San Francisco Bay Area Rapid Transit District

**Addendum to Final Initial Study/Mitigated Negative
Declaration for the Hayward Maintenance Complex
Project**

**COMPONENT REPAIR SHOP—BUILDING 3
REPLACEMENT**

March 27, 2013

Figure B

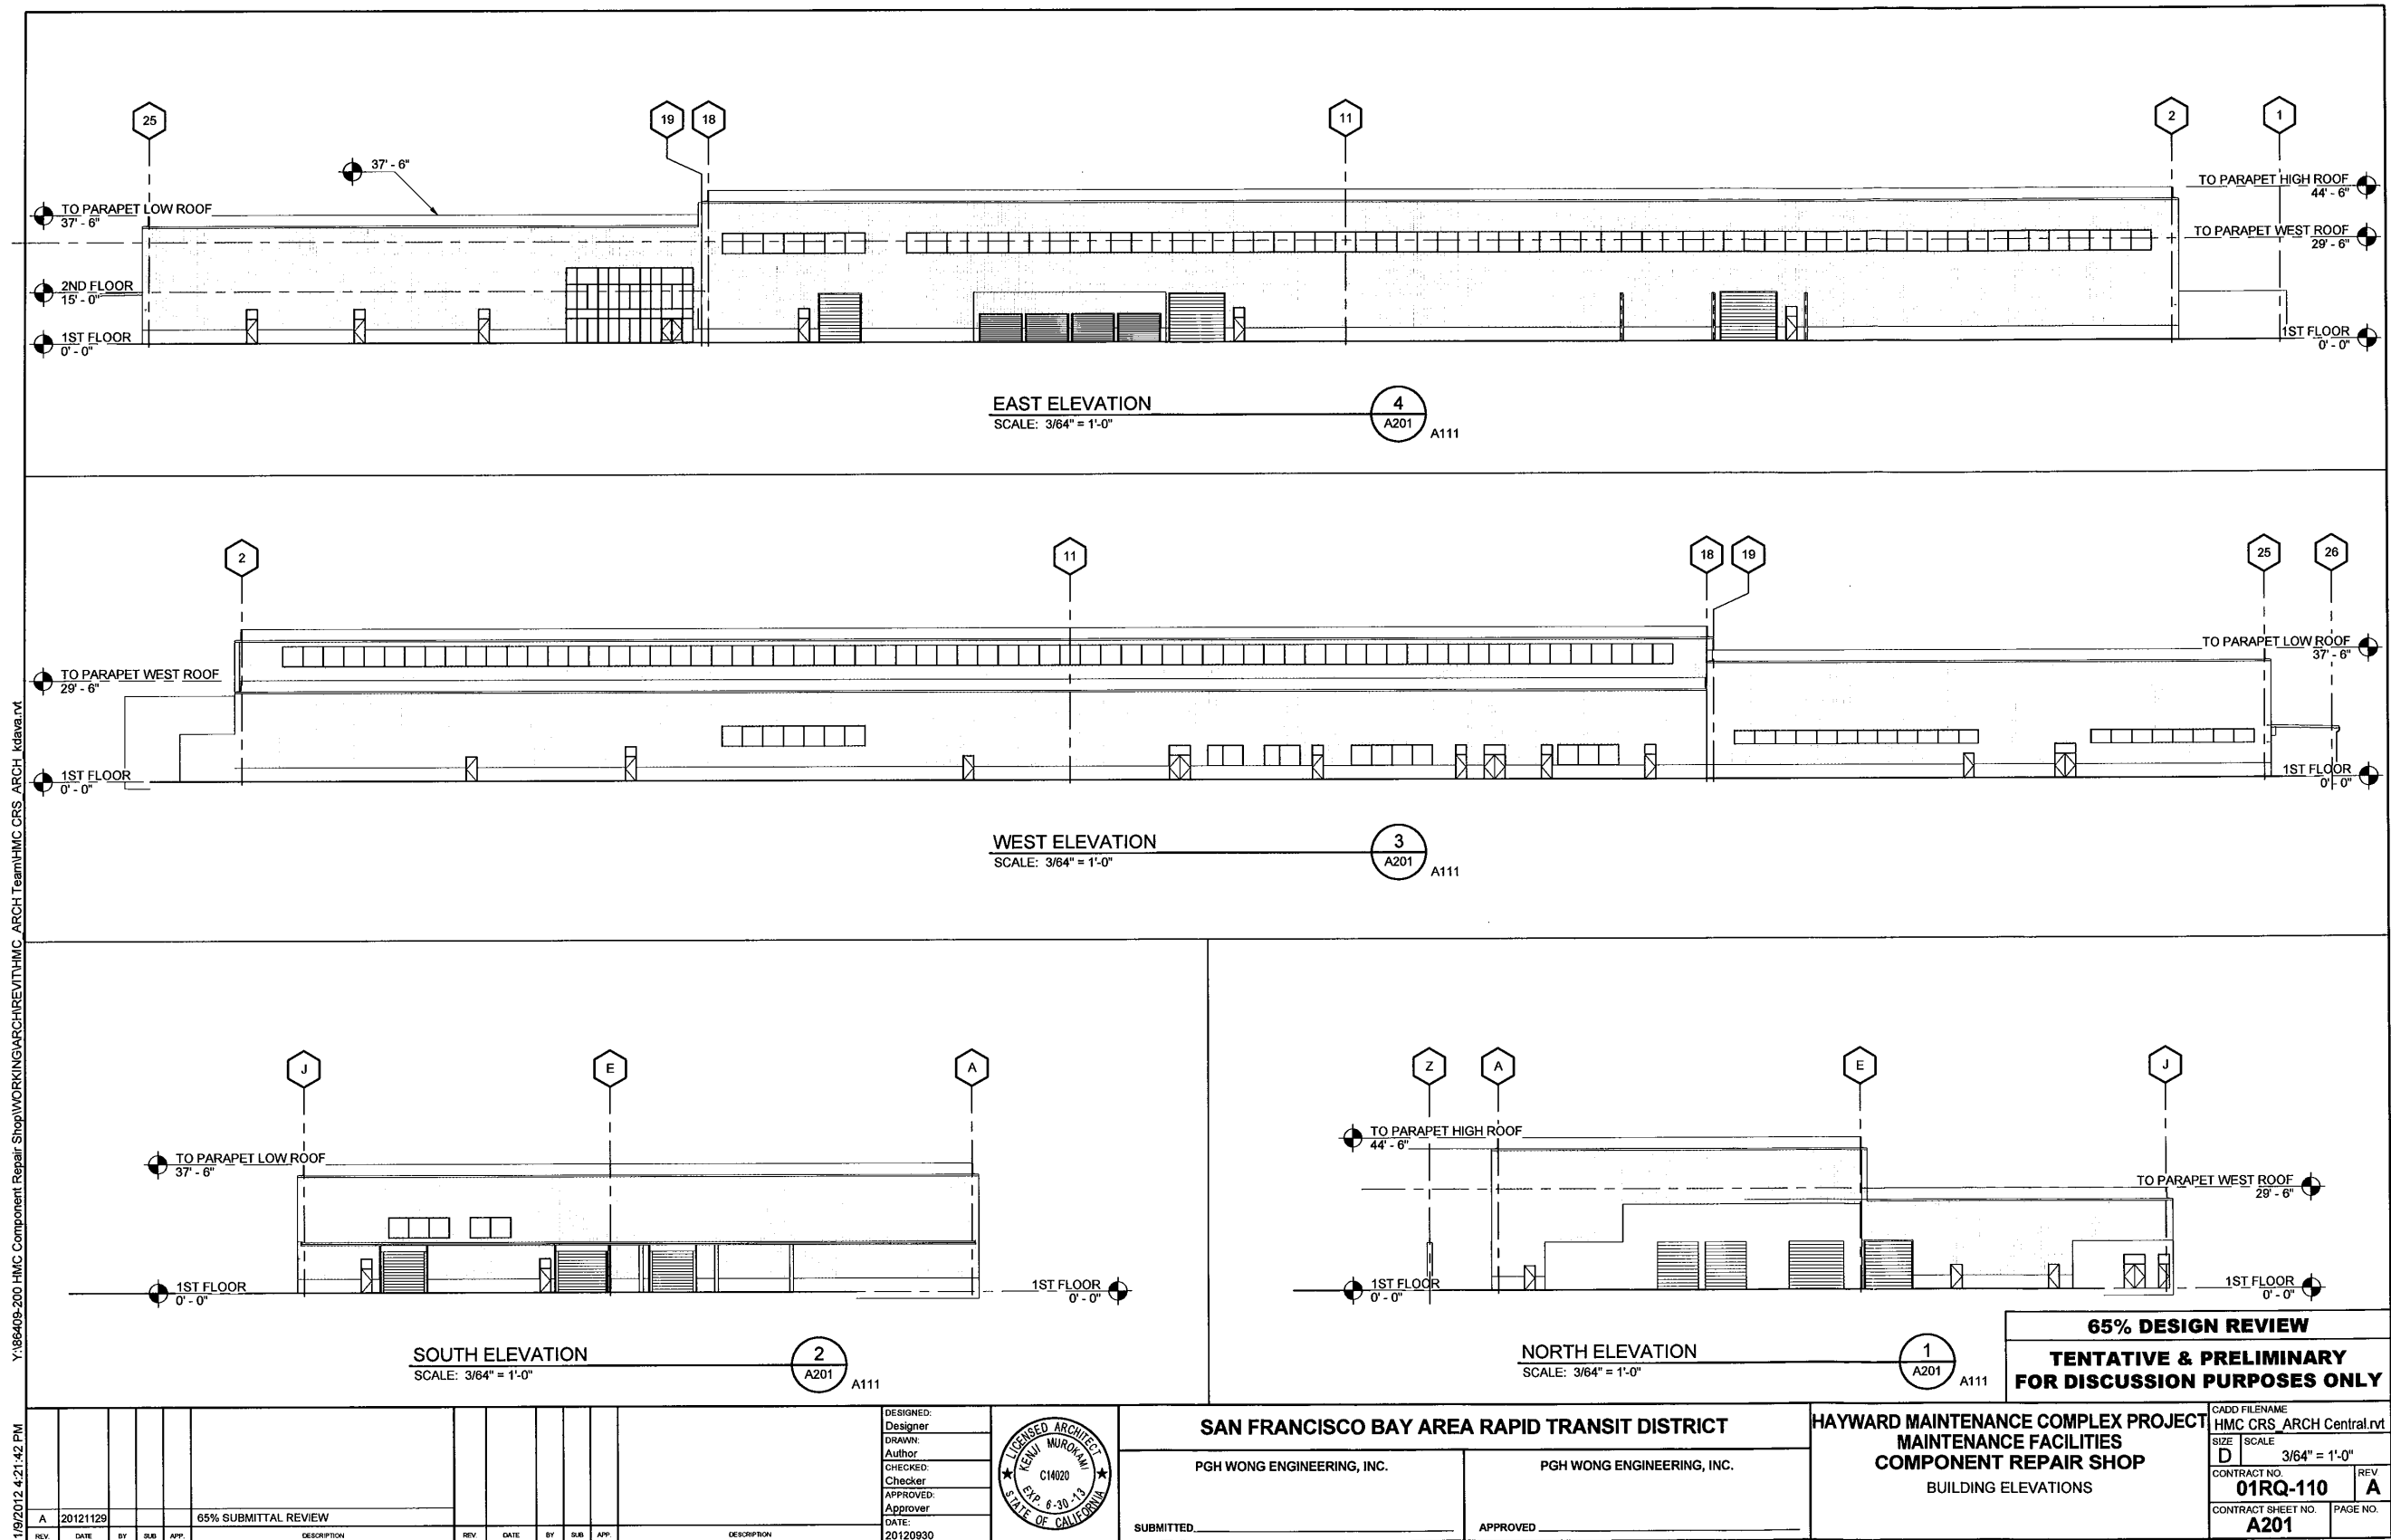
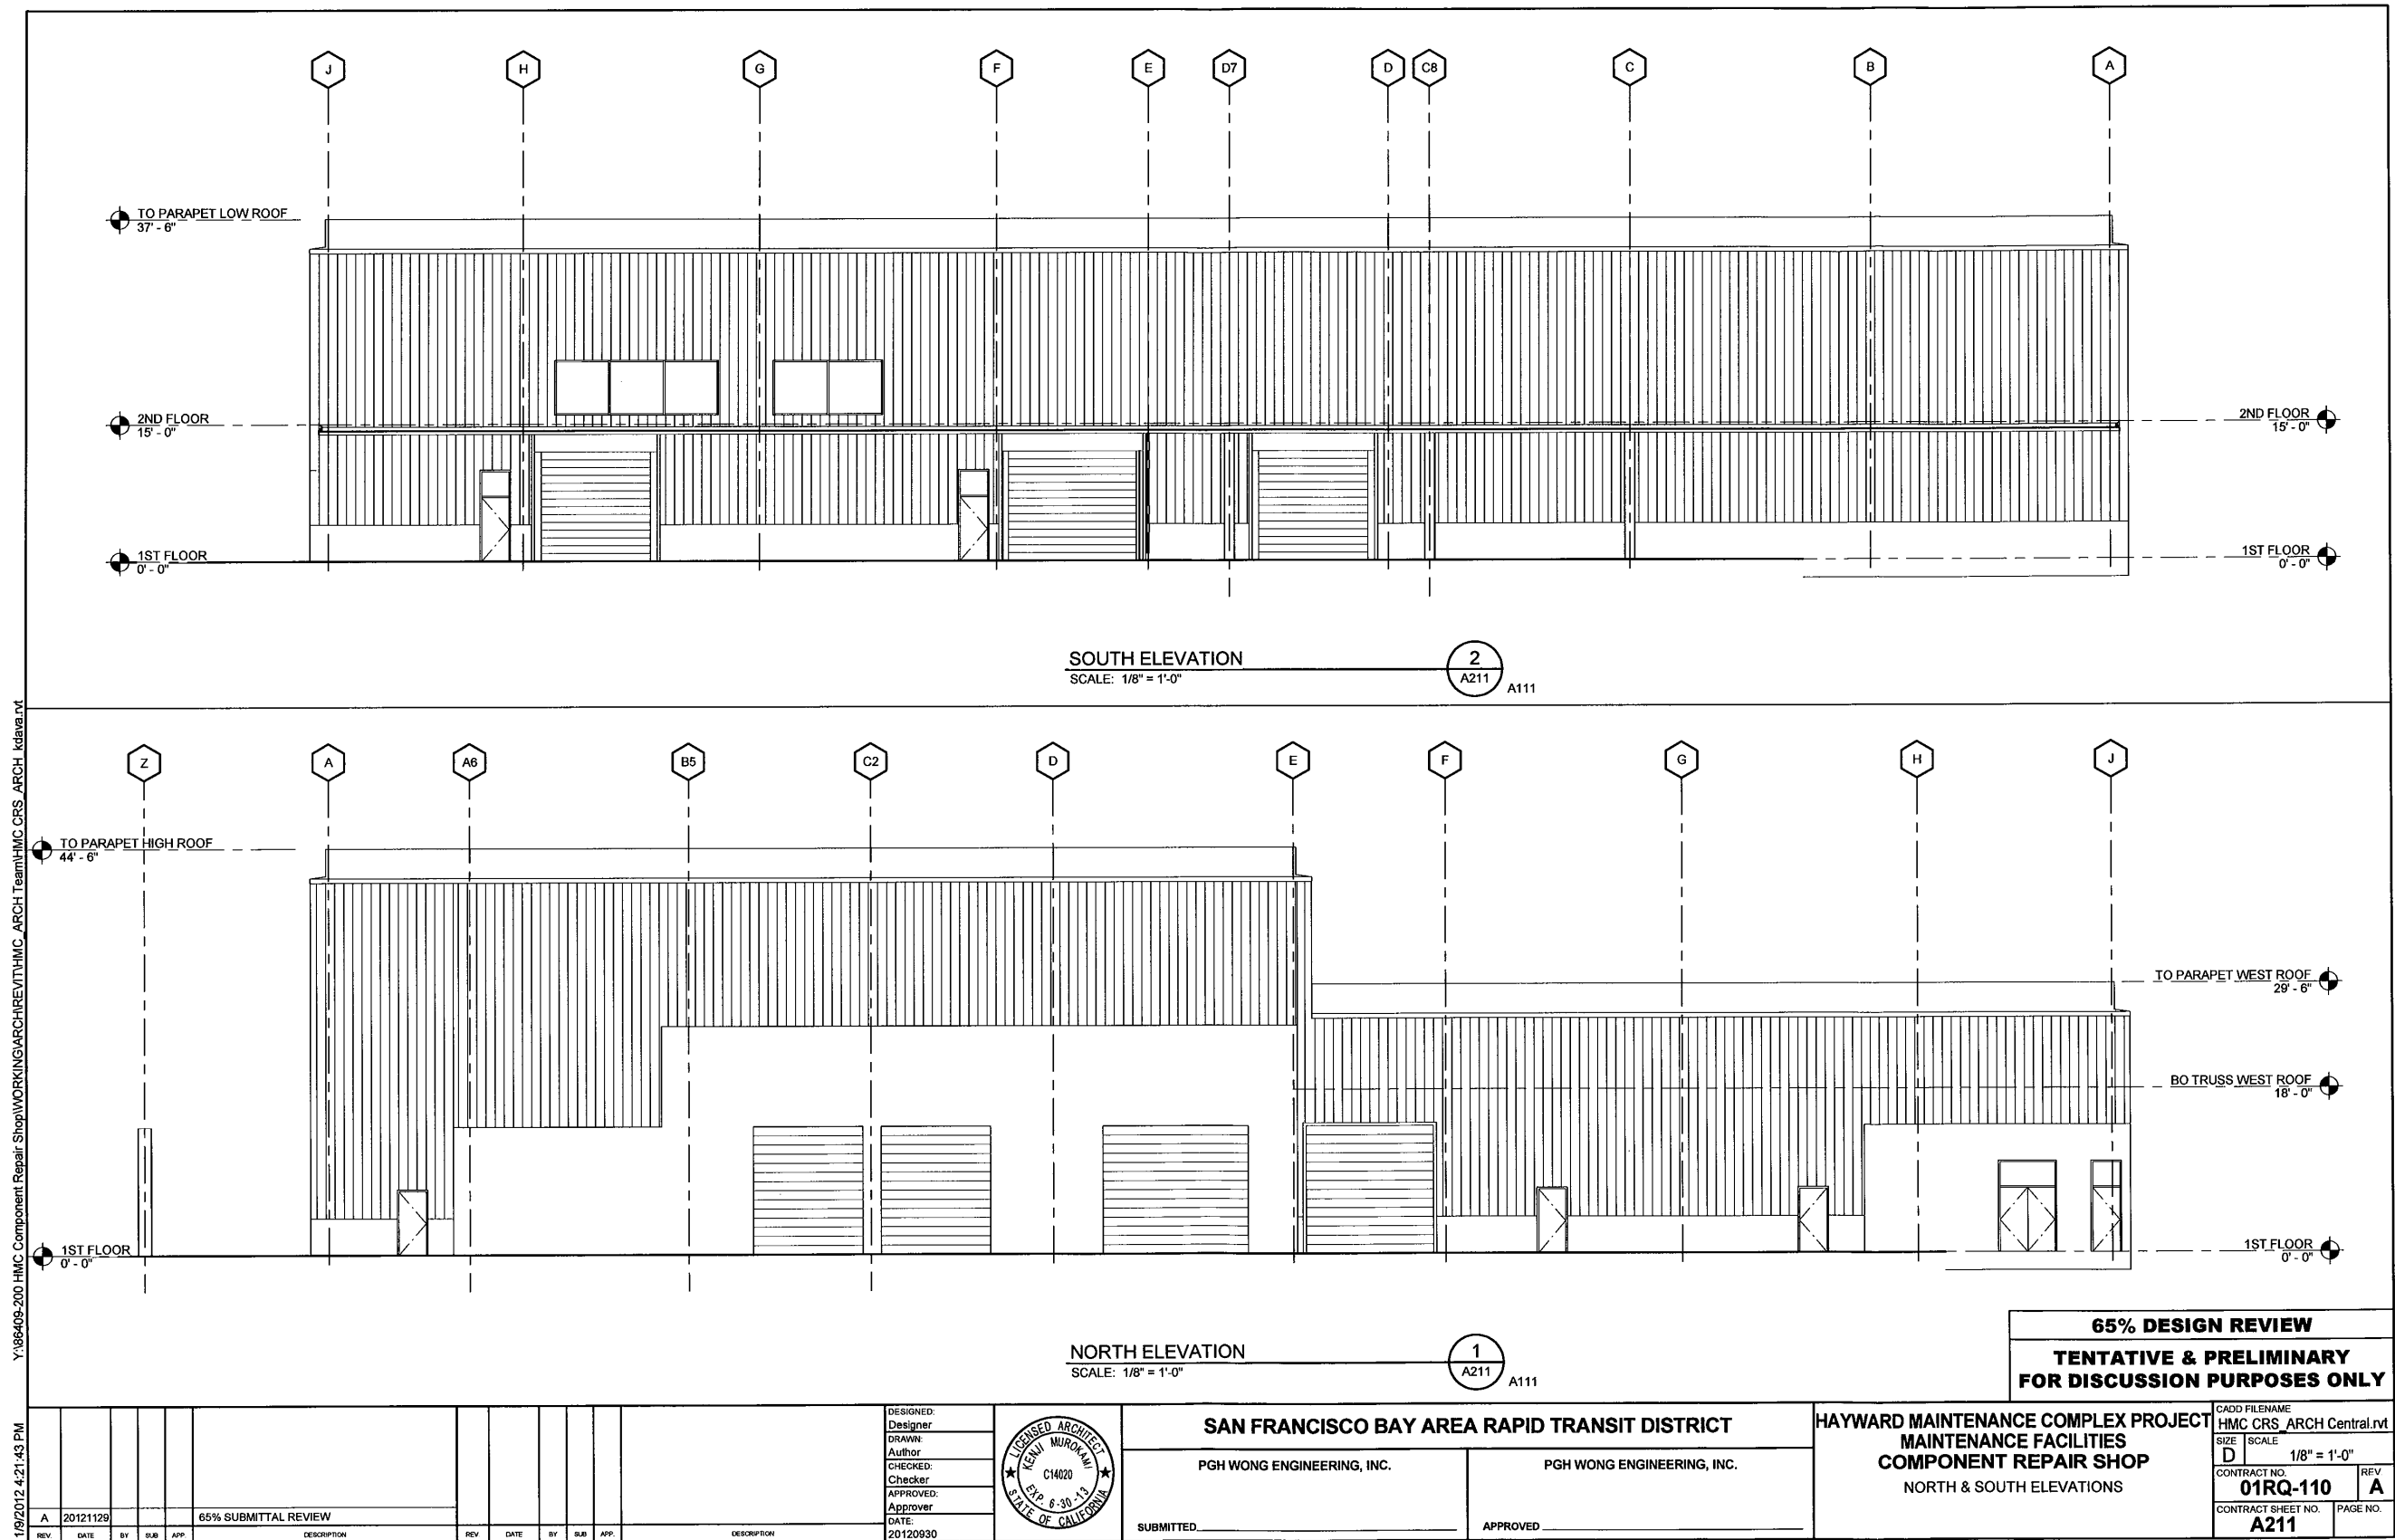
Therefore, the HMC Project has been modified to demolish Building 3 and replace it with a new structure to house the Component Repair Shop.

The new structure would have the same approximate horizontal dimensions (600 feet long, 200 feet wide) as the existing structure and a 125,530 square-foot footprint. Compared to the existing footprint, this is a 4.6 percent increase in square footage. Interior space will be expanded to 157,930 square feet with the addition of 32,400 square feet on a mezzanine floor for offices and the Electronic Repair Shop, representing a 32 percent increase in available office space compared with the existing building footprint.

The new structure would be shifted 20 feet to the south of its current location. The increased distance will provide additional width to accommodate the north-south roadway and an easement for a relocated water line as well as other utilities between the new Vehicle Repair Shop and the Component Repair Shop. The roadway was described in the IS/MND and would connect the existing driveway serving the west side of the HMC project to Sandoval Way and the Hayward Main Shop area. This southward shift would reduce the distance between the Component Repair Shop and adjacent structure on the south, Building 2, from 100 feet to 80 feet. The new building would be a structural steel frame building clad with metal panels. The new structure would be higher than the 26-foot-tall existing structure. The new building roof line would vary in height, with three different roof levels of 30 feet, 38 feet and 45 feet. (See Elevations, Figure B.) The Component Repair equipment and operations within the building would be the same as originally proposed. The number of employees in the Component Repair Shop would stay the same as originally proposed in the IS/MND (75 during peak occupancy, 150 total).
